### **FEDERAL INFORMATION REQUEST T(3)-08 – COMPILED RESPONSE DOCUMENTS AND RELEVANT COMMUNICATIONS**

### **HAMMOND REEF GOLD PROJECT – TAILINGS MANAGEMENT FACILITY, ADDITIONAL 3D GROUNDWATER MODELLING**

PROJECT NO. 1656263 CONTROL 0001 REV. 0.0 FIGURE 3

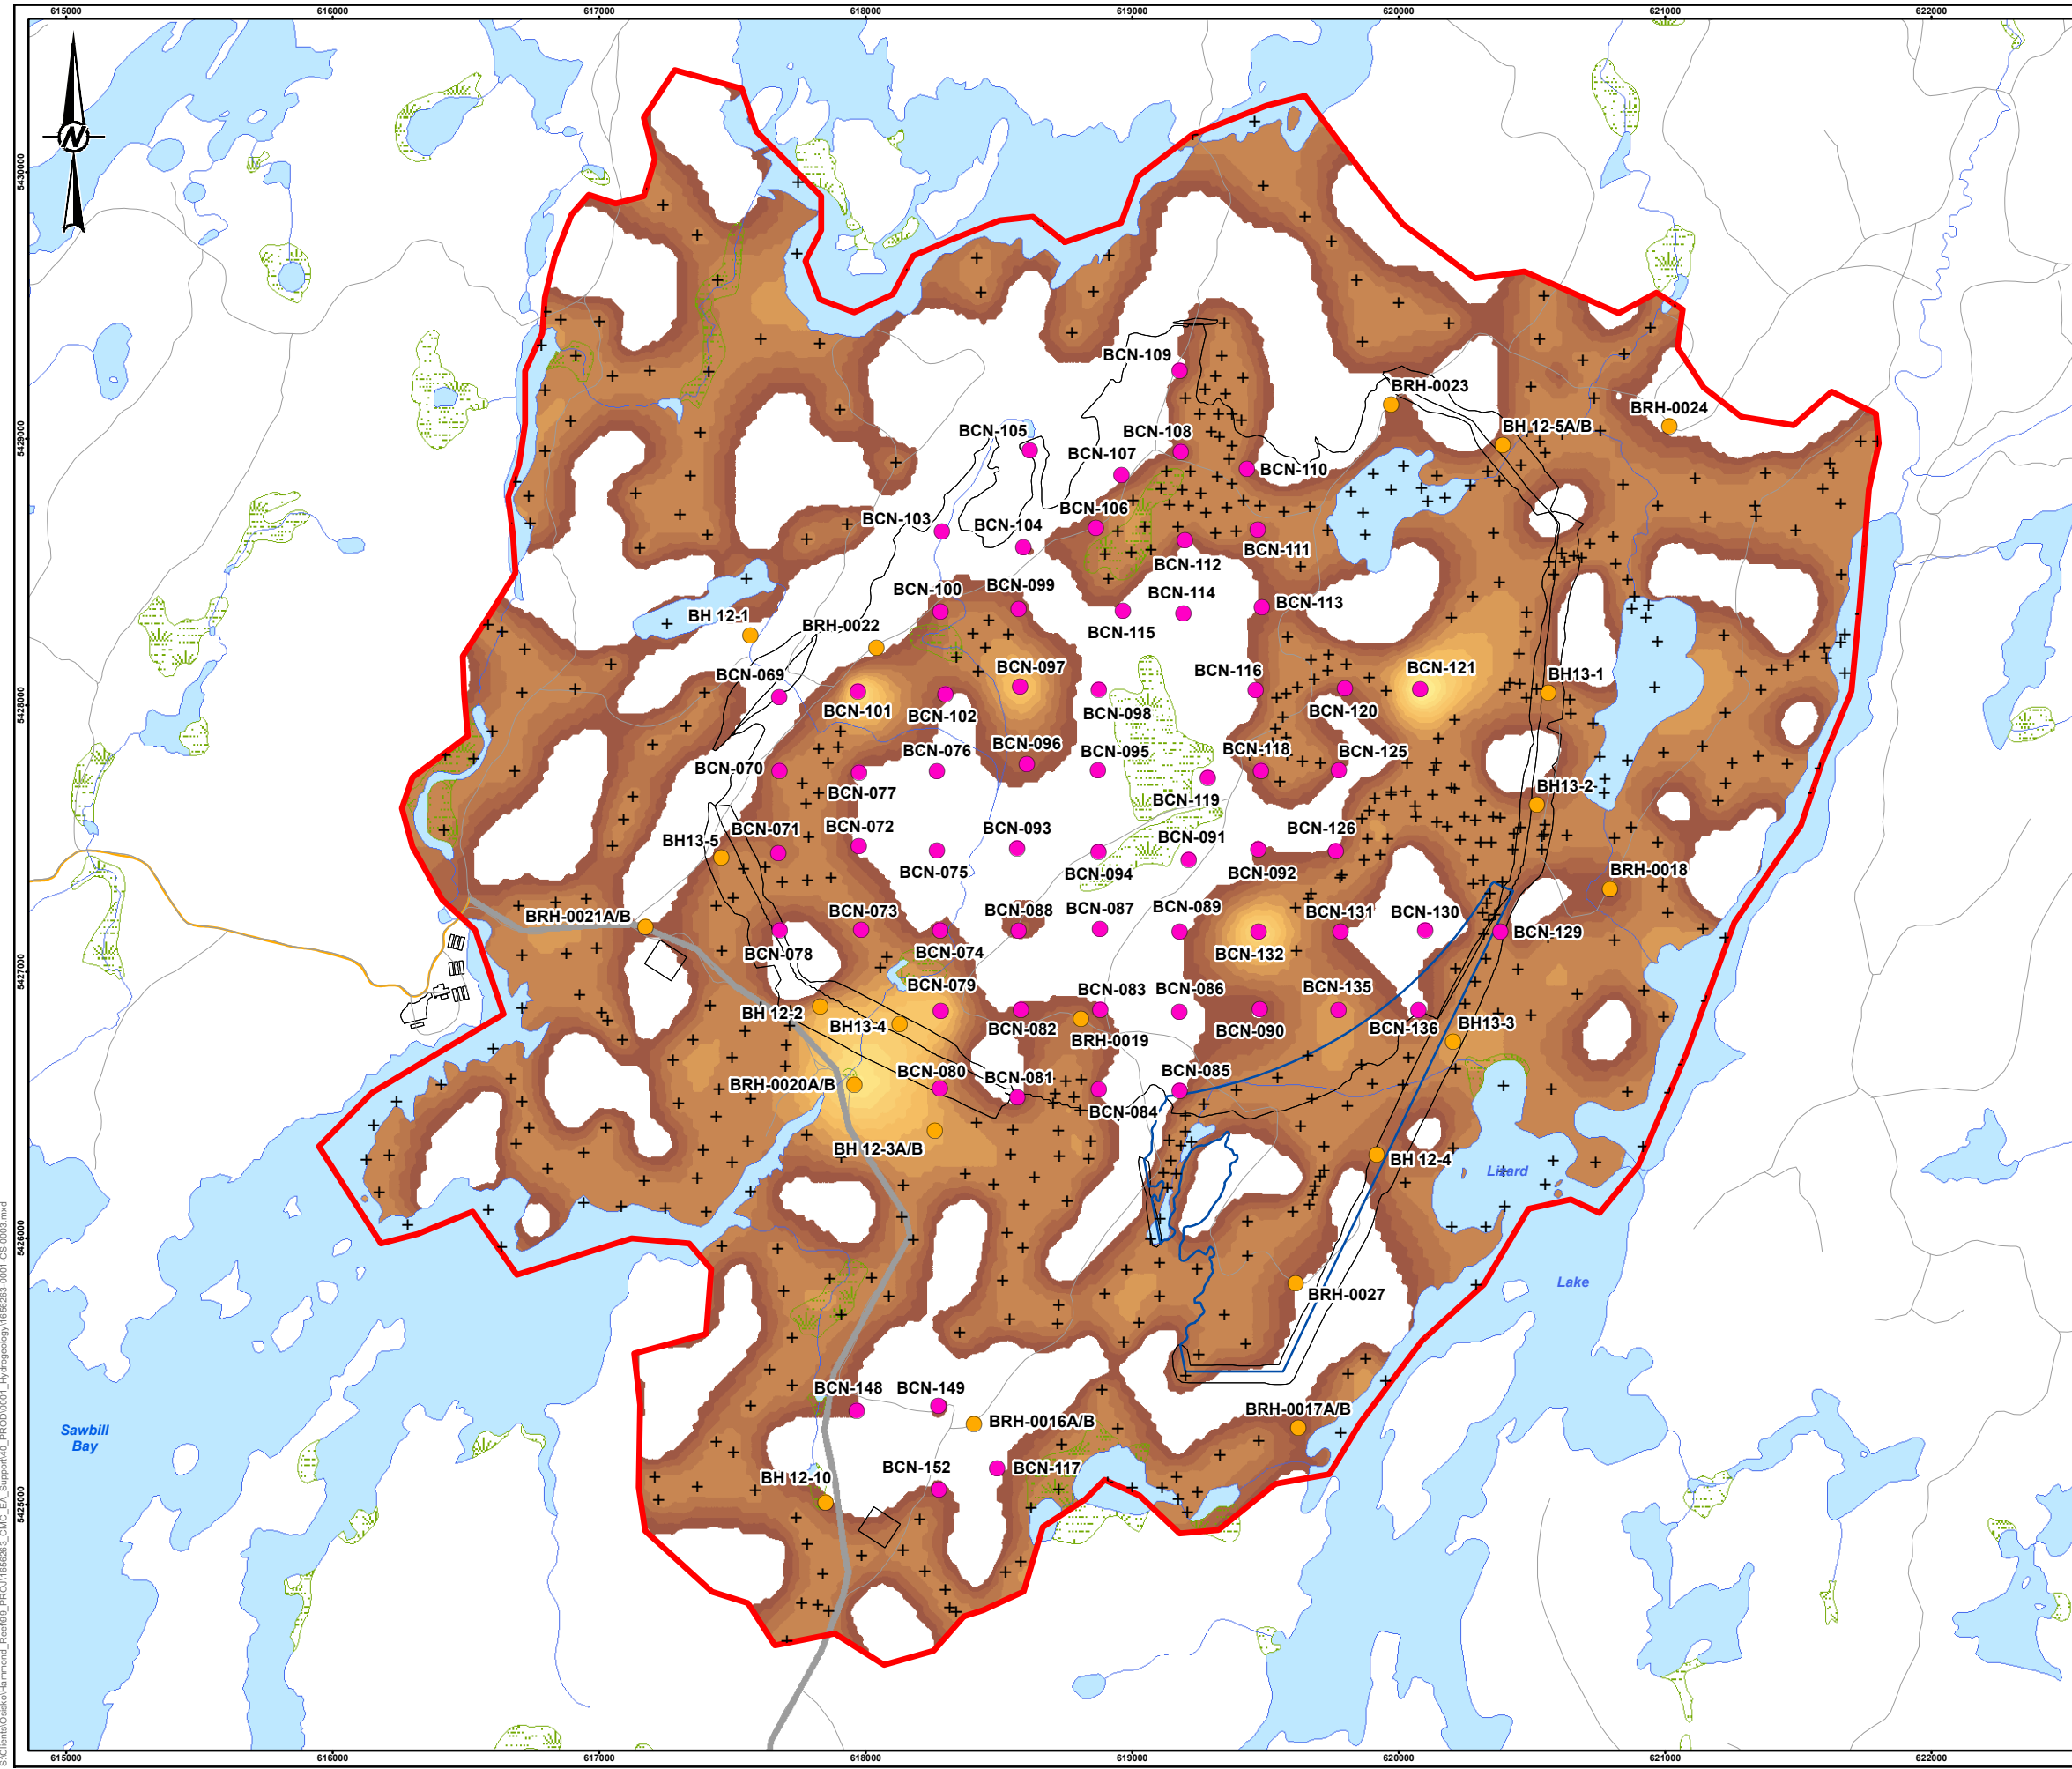
opinion that the bedrock valleys may be more continuous than suggested in Figure 3 (Golder Associates, 2016b); some of the wider bedrock troughs are more continuous and may be deeper than modeled, as demonstrated by the many NNE-SSW trending valleys and lakes in the area (e.g., Lizard Lake). These buried bedrock troughs are somewhat under-represented in the data set as their wide and flat valley bottoms are less accessible due to the presence of peat bogs (see Figure 2). Also, the delineation of the surficial mapped polygons from Stea's (2010) map would require many more data points than the number of boreholes and therefore would bias the interpolation to that dataset. NRCan proposed that the methodology would provide a more conservative interpolation if more "dummy points" were used to ensure continuity in potentially significant buried valleys.

The sediment thickness was re-interpolated (Figure 3) using more "dummy points" in the updated Technical Memorandum (Golder Associates, 2016a) with the result of having more continuity in potential buried valleys.

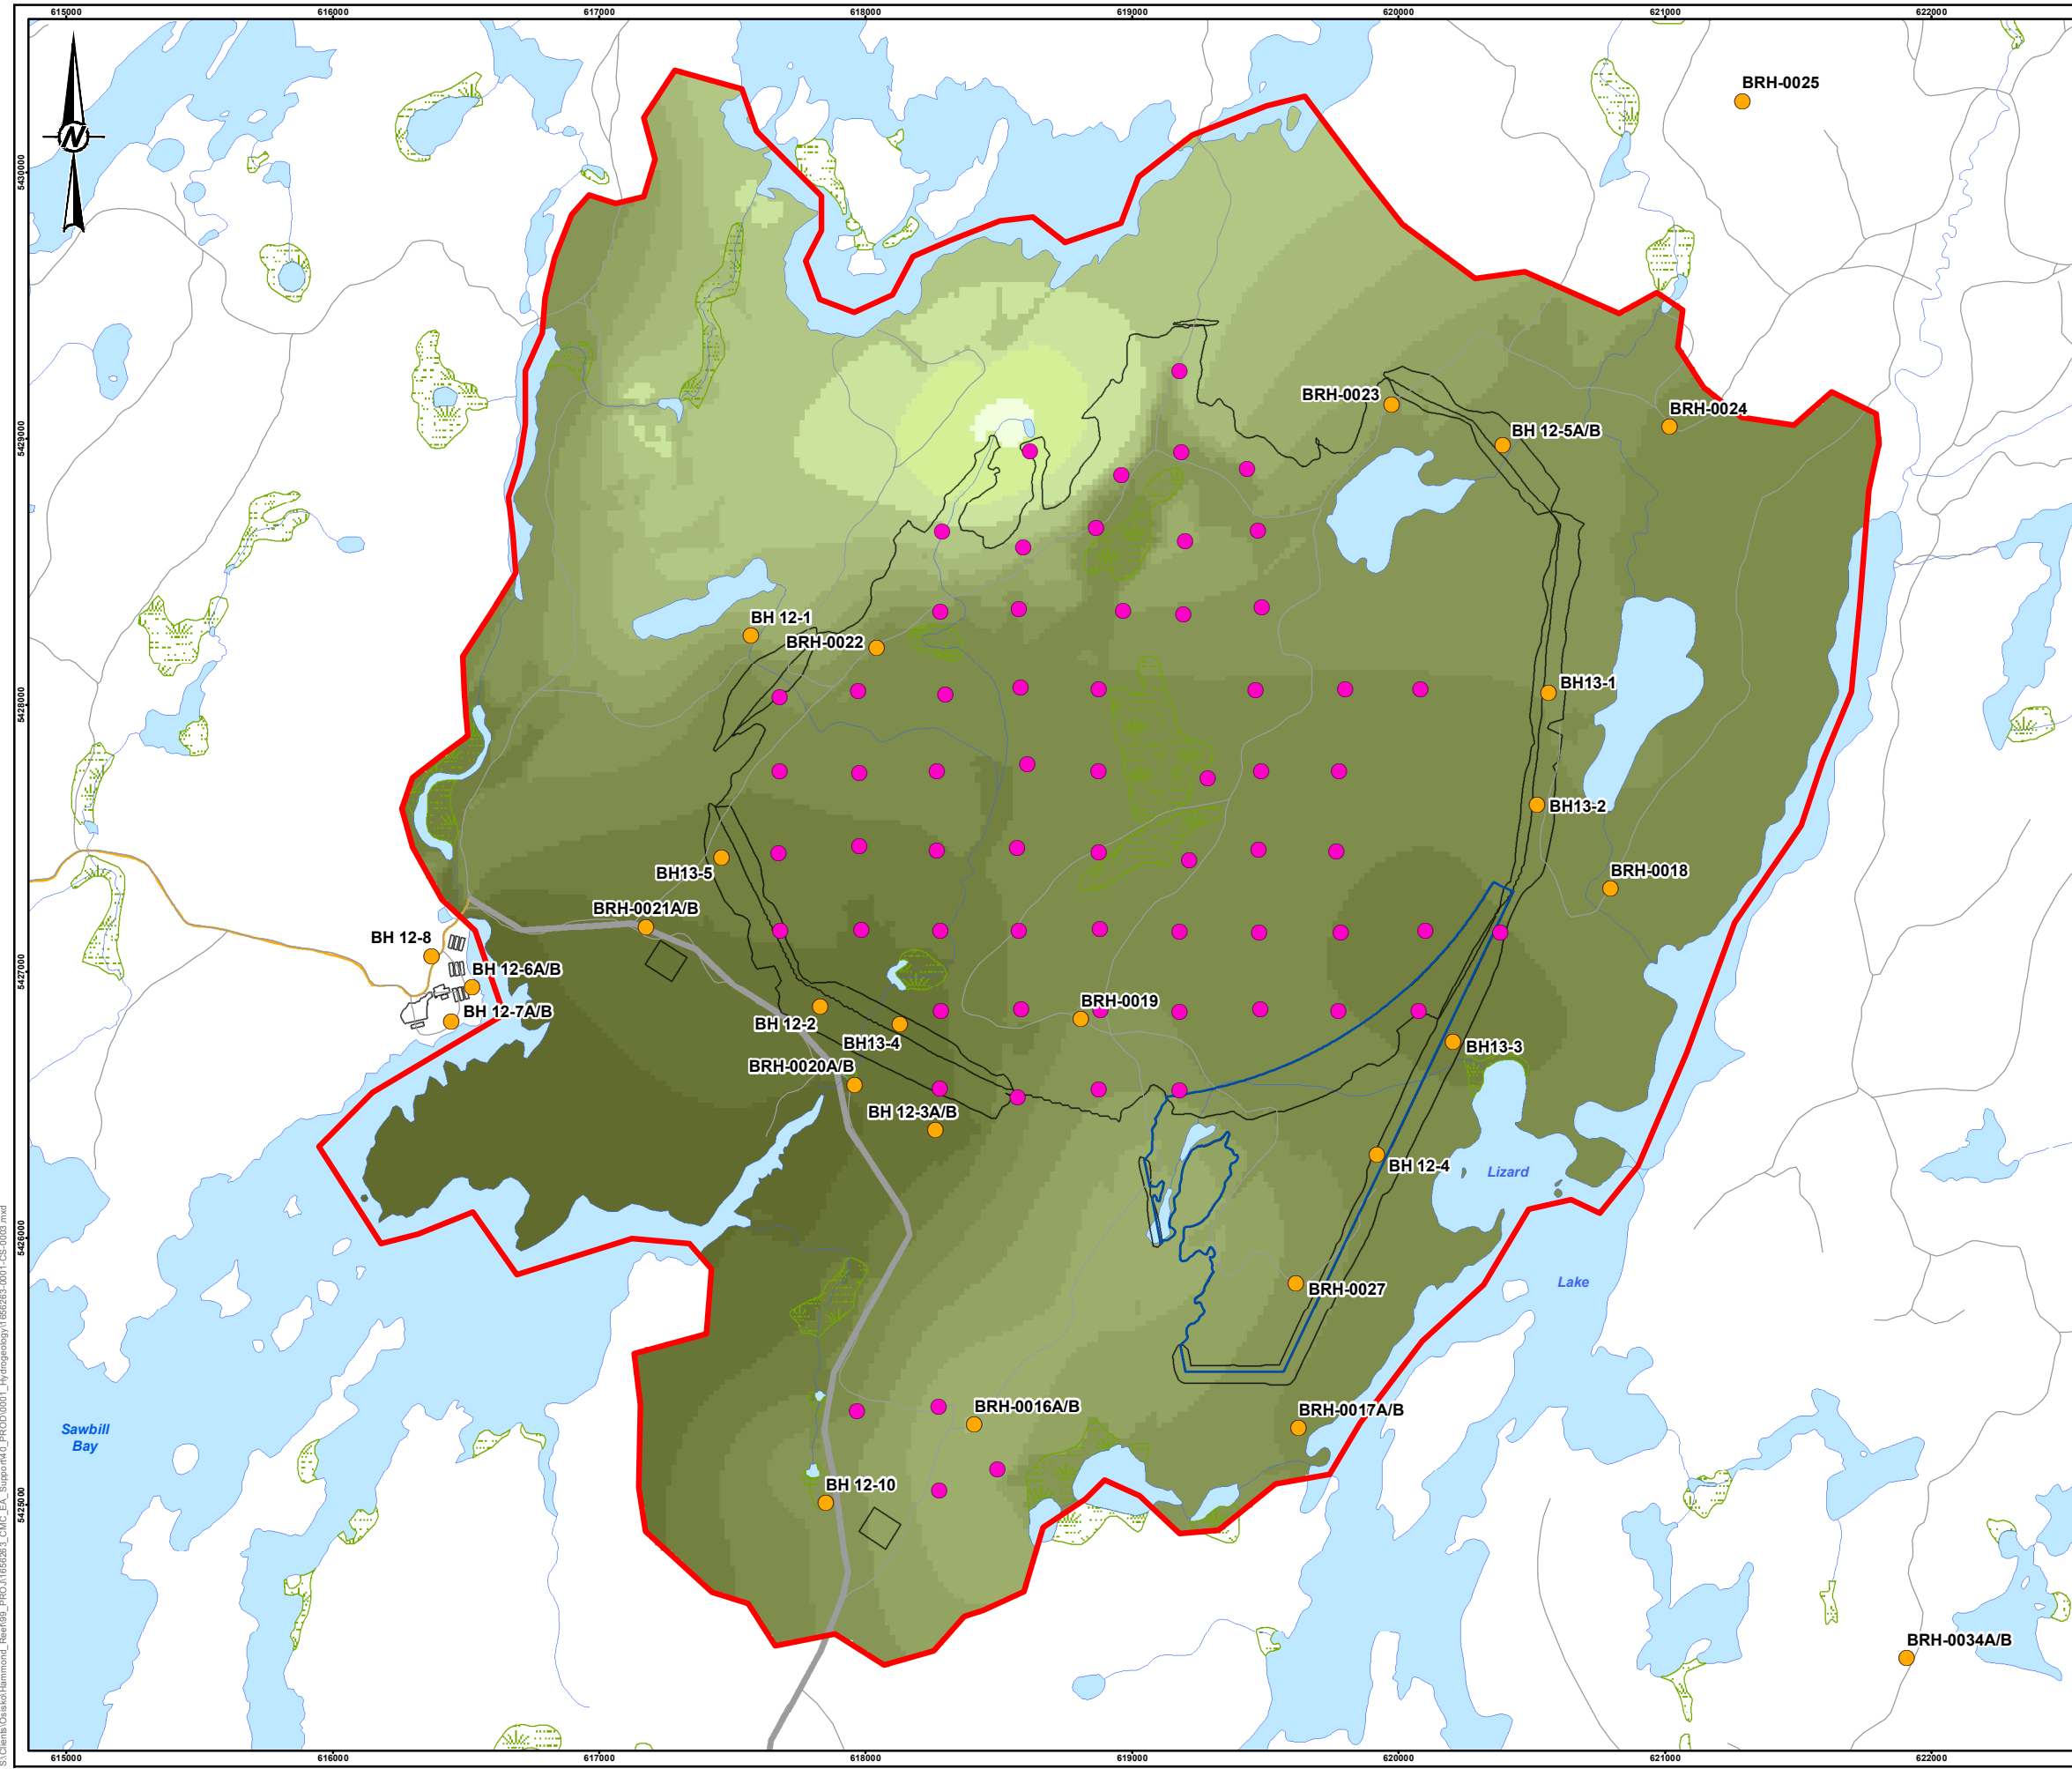
NRCan is of the opinion that Figure 5 may represent the shallow groundwater elevations in the valleys but the absence of data from the bedrock uplands does not allow groundwater levels in the uplands to be included. As a result, the map suggests a different conceptualization of groundwater flow than is likely the case. NRCan believes that groundwater levels in the uplands will also be a subdued replica of surface topography. This appears to be the case in the West Pit Area (e.g., Figure 2-10 in Golder Associates, 2013). Consequently, the map of shallow groundwater levels would resemble that of a muted surface topography; in other words it would resemble Figure 1 more than Figure 5. The result is that groundwater flow in the bedrock uplands is probably much more localized and directed towards the valleys and that groundwater flow in the valleys follows a more regional pattern similar to that of Figure 5. The presence of competent bedrock in the uplands at elevations above that of the valleys may form hydraulic barriers to the regional flow patterns implied in Figure 5 (e.g., bedrock ridges at BCN-076 and BCN-075, at BCN-098, BCN-095 and BCN-093, and at BCN-087, BCN-089 and BCN-092 (and others) have competent bedrock above the ground elevations of the adjacent valleys).

NRCan is not suggesting that additional water level measurements are needed for the bedrock uplands since that would be onerous and may not add significantly to the modelling effort. Rather, NRCan would like to ensure that Golder Associates and the FRT agree on the conceptualization of groundwater flow, and the groundwater modelling should not attempt to replicate the groundwater flow patterns shown in Figure 5 as suggested by section 4.0 (item 1b). A pragmatic approach may be to make some assumptions about the depth of the water table in the uplands based on boreholes in the West Pit area and possibly using “dummy points” in upland areas for map interpolation.

- 6) NRCan is not convinced that the current map of inferred shallow groundwater elevations (Figure 5, Golder Associates, 2016a and 2016b) is valid (Comment 12) and therefore it may not be useful for baseline model calibration as suggested in section 4.0 of the Technical Memorandum. The groundwater elevation map could be updated to reflect the lack of data in the uplands and the interior of the TMF. Areas mapped as peat bogs by Stea (2010) could be included as areas where the water table is at or near the ground surface. Water level depths in bedrock uplands could be estimated based on data from borehole or piezometer data in the mine area and then used as “dummy points” in the interpolation. The actual groundwater elevations in the uplands would be of lesser importance than the conceptual
